Appendix C:

Project Correspondence

This appendix contains correspondence regarding the Long Bridge Project.

Figure 1 – Conceptual Alternative Tunnel Alignments 14th Street Bridges (incl. WMATA and CSX)

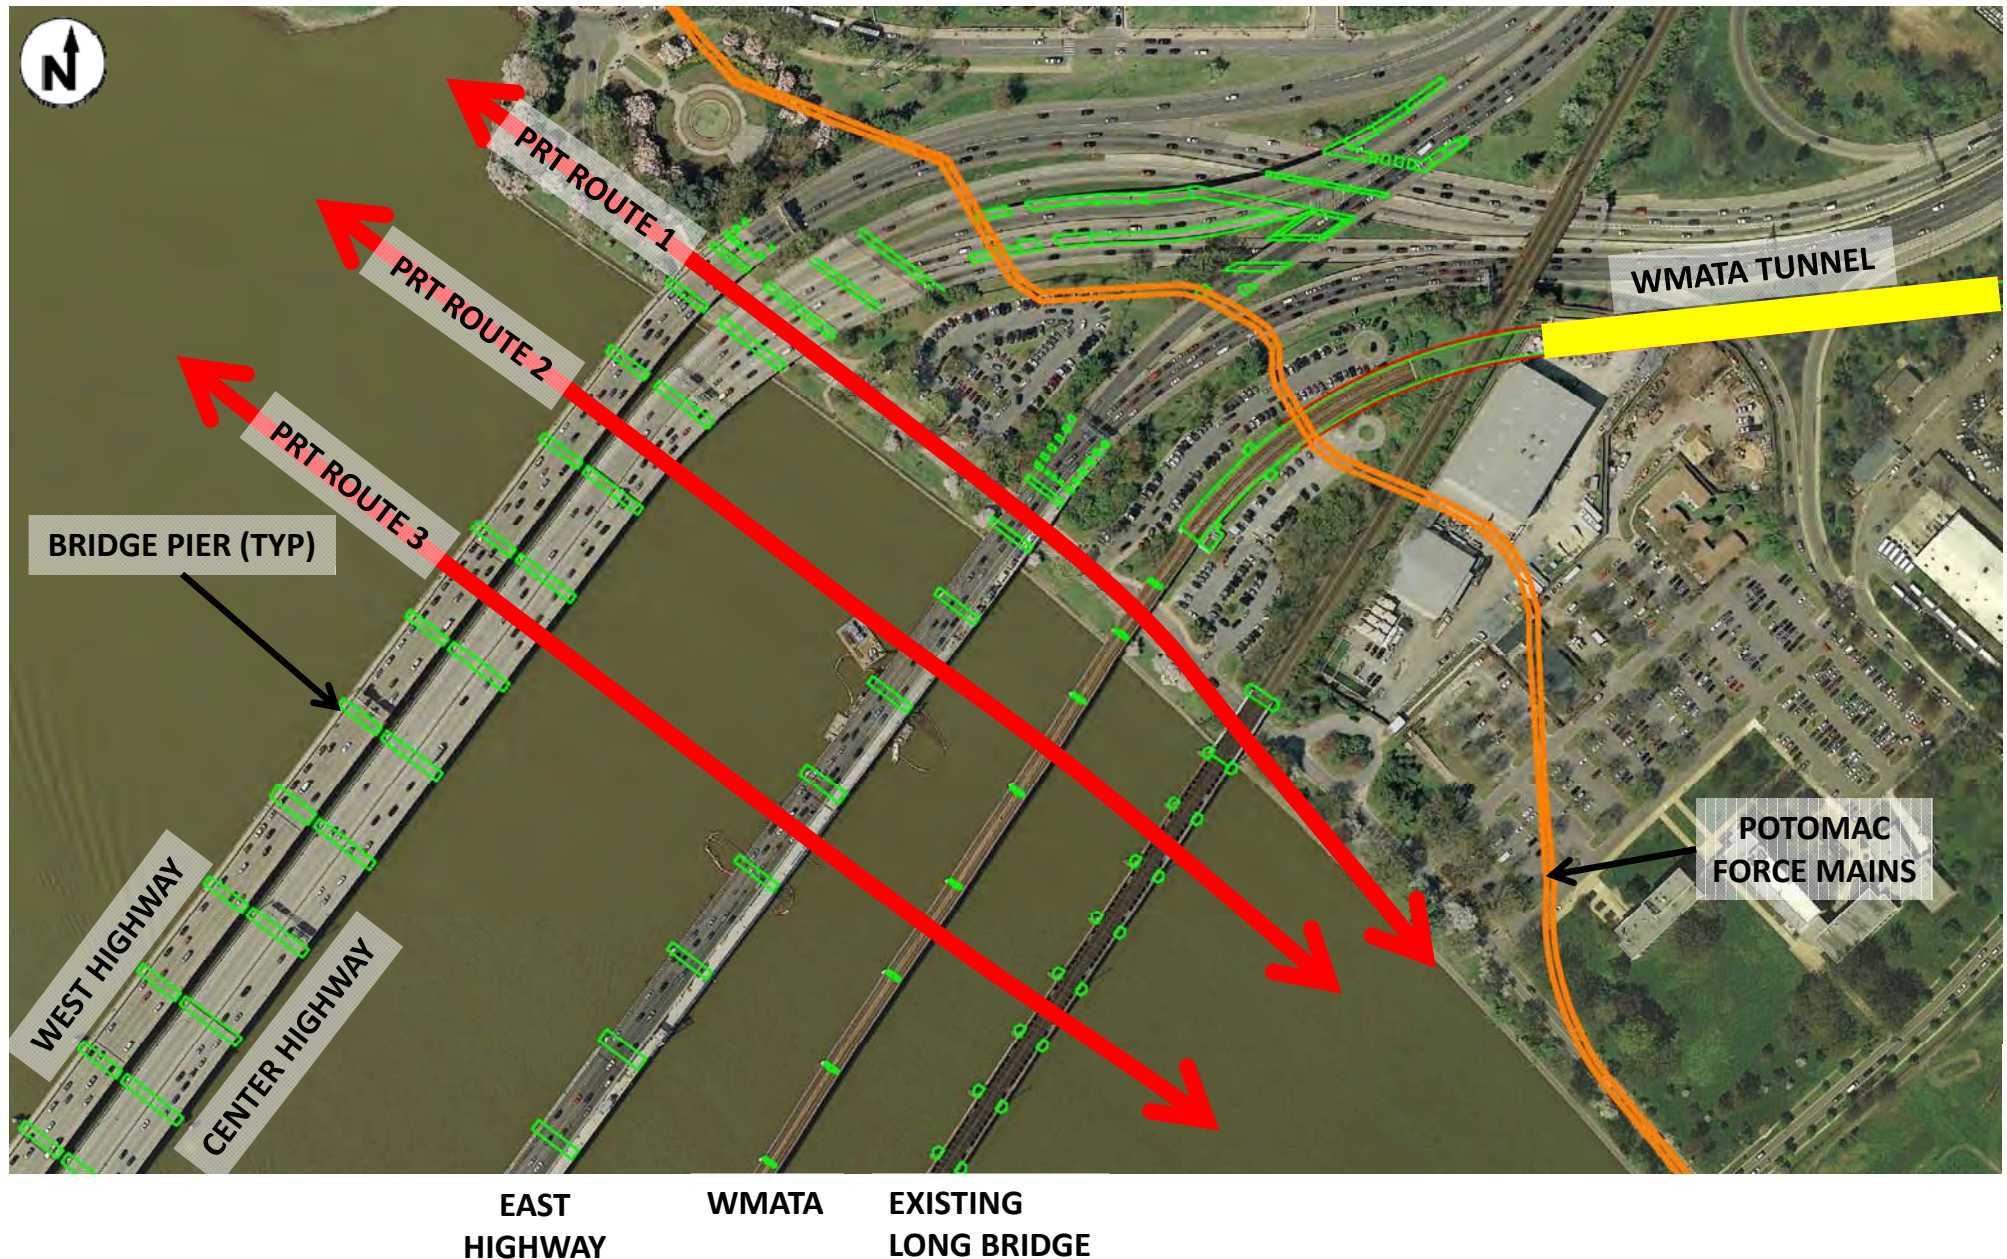
The Potomac River Tunnel (PRT) Project, currently in the planning phase, is the portion of the DC Clean Rivers Project which will provide control for CSOs along the Potomac River, which are generally between the Lincoln Memorial and Georgetown. The PRT will consist of a storage/conveyance tunnel and supporting infrastructure, including diversion facilities connecting to existing sewers, drop shafts, overflow structures, and ventilation control facilities. DC Water, as co-lead agency with the National Park Service, is currently preparing an Environmental Assessment for the PRT project.

The PRT will convey flows captured from the Potomac River CSOs via gravity to the existing Blue Plains Tunnel and Blue Plains Advanced Wastewater Treatment Plant, generally via an alignment parallel to the eastern shoreline of the Potomac River. In the area of the 14th Street Bridges (including the Long Bridge), the PRT must avoid the deep foundations of each of the five existing bridges. Based on preliminary review of record drawings provided by each of the bridge owners, Figure 1 shows potential alignments being considered for the PRT as it passes through the Study Area. Figure 2 includes a cross section showing the PRT potential alignments relative to the existing Long Bridge deep foundations, based on drawings provided by CSX in April 2015. All alternatives included in the Long Bridge Project EIS should consider how any proposed foundations will be coordinated with the potential PRT alignments, potentially including providing piers and piles aligned with those beneath the existing bridges upstream. This includes the bike-pedestrian crossing, which at the meeting was presented as a possible separate project. The vertical alignment of the PRT is largely driven by the elevation of the existing Blue Plains Tunnel downstream, the existing WMATA Blue/Orange/Silver Line Tunnels upstream, and the need to maintain positive slope for gravity flow. As such, the vertical alignment of the PRT will be substantially as shown in Figure 3. The proposed Long Bridge Project and bike-pedestrian crossing alternatives presented in the December 14, 2017 meeting warrant close and early technical coordination with DC Water to determine any possible impacts prior to completing both projects' NEPA coordination.
